SUBJECT: Rev 14 to "Emergency Response Manual." W/930809 ltr.

Donald C. Cook Nuclear Plant Units 1 and 2  
Docket Nos. 50-315 and 50-316  
License Nos. DPR-58 and DPR-74  
INDIANA MICHIGAN POWER COMPANY  
EMERGENCY RESPONSE MANUAL

Reasons for Revision 14 to the  
Indiana Michigan Power Company  
Emergency Response Manual

### FLOOR PLAN OF THE JPIC

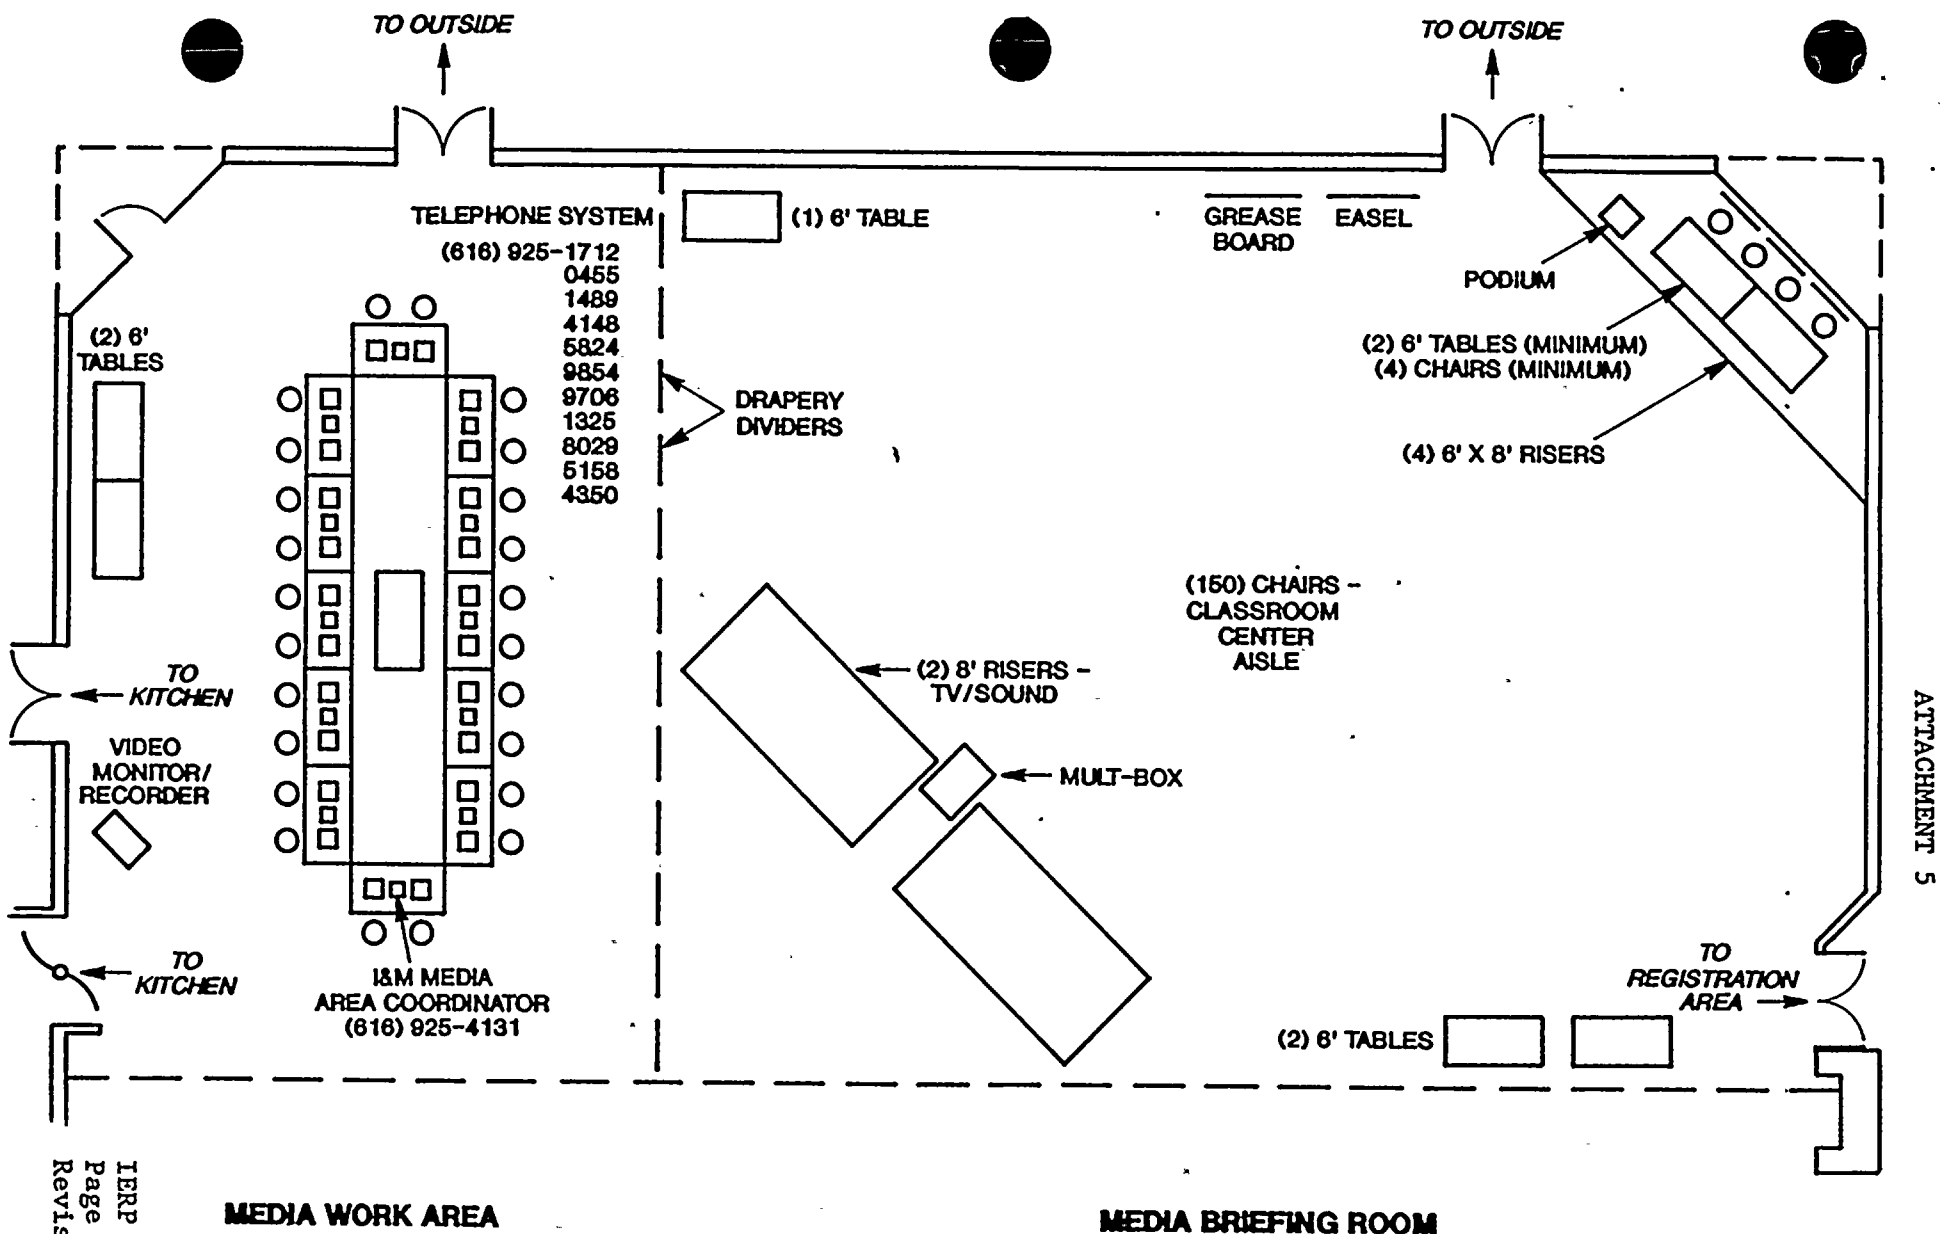
Updating drawings to reflect  
revised JPIC setup

# MEDIA MONITORING - JPIC

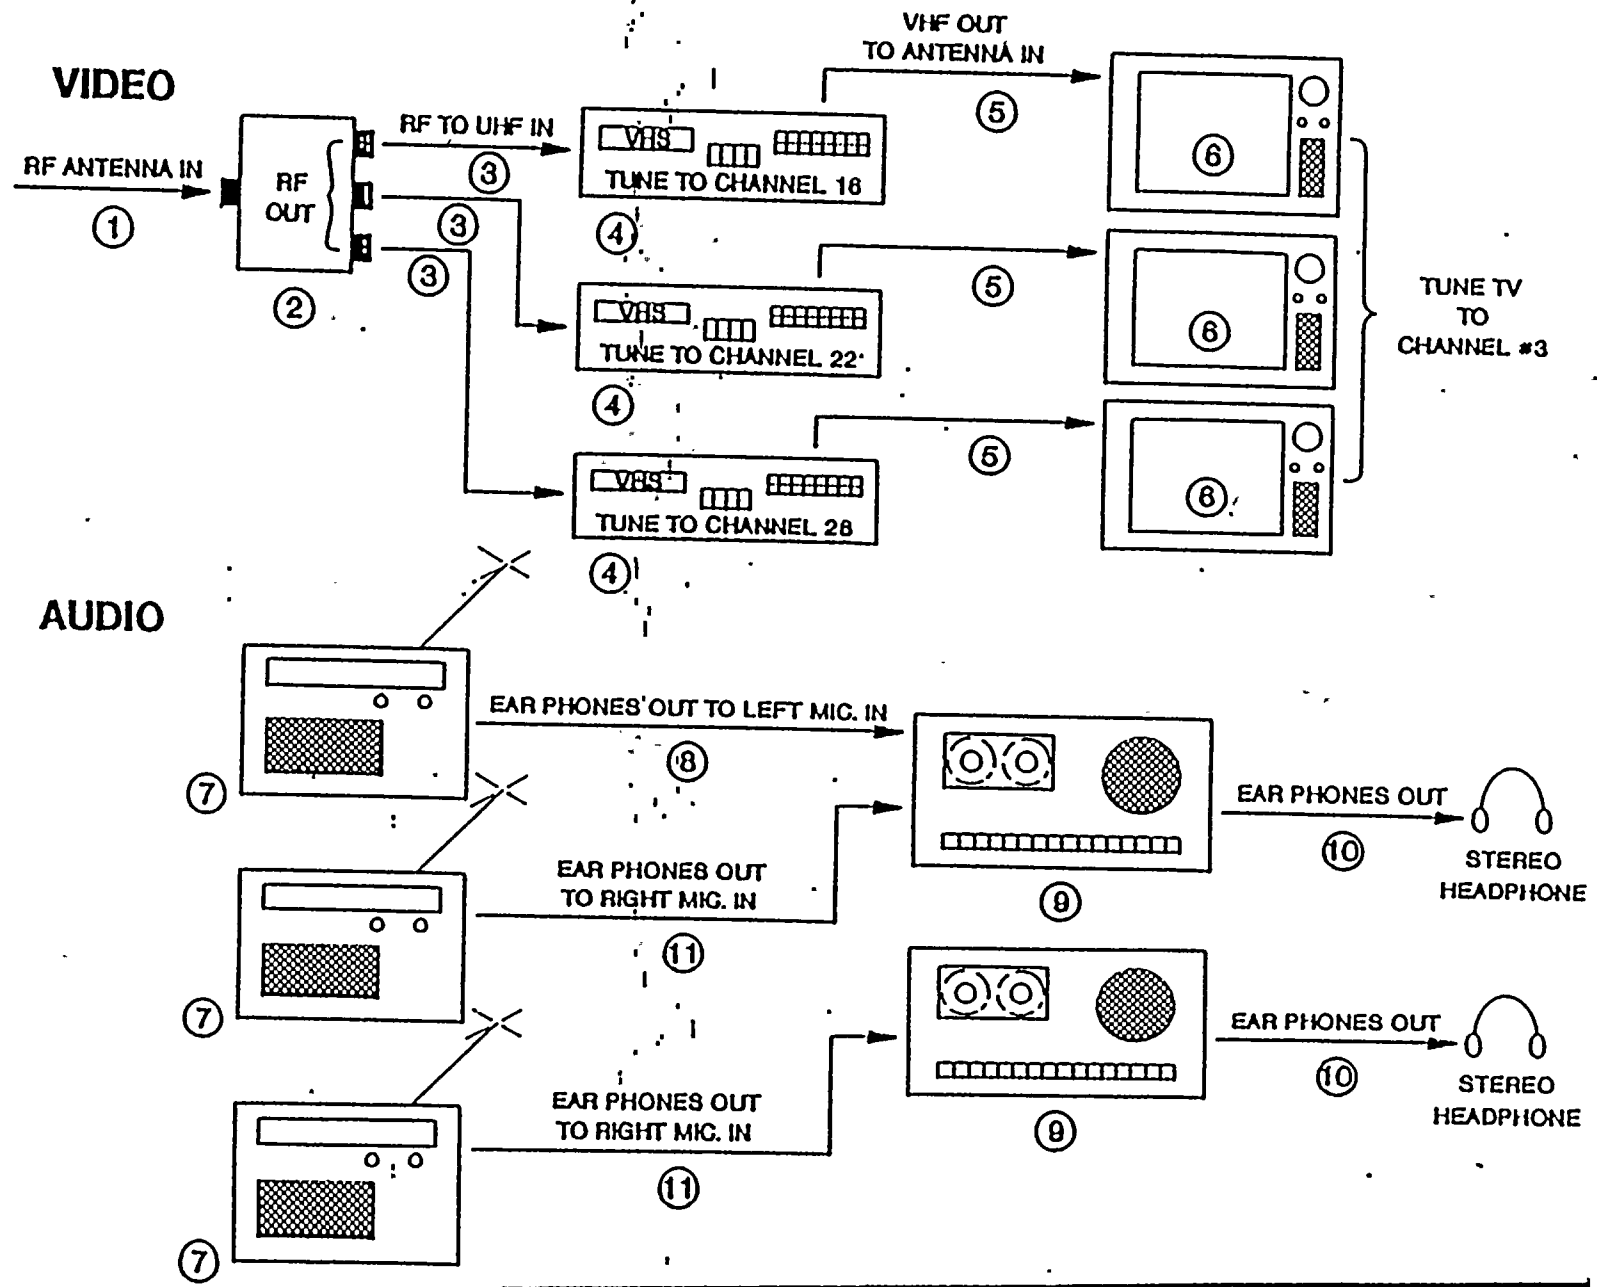
Changes in setup of equipment
